Caltrain Bicycle Advisory Committee Subcommittee on Understanding EMU Design Constraints

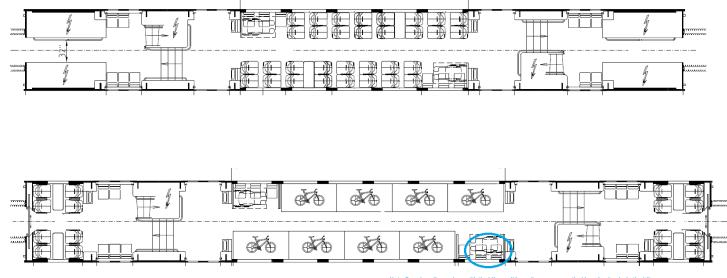
Q6. Can you share more detailed engineering drawings of the proposed bike car layouts?

A6. Please see below. The top image is the coach car's lower level. The bottom image is the bike car's lower level. Detailed engineering drawings are proprietary to the train builder.

Note: Based on discussions with the bike coalitions, there are no vertical hanging hooks in the bike cars the flip seats in the circled area have been removed; and bikes may be stored in this location. This is inteded to clarify the deletion of the flip-up seats and added associated bike storage.
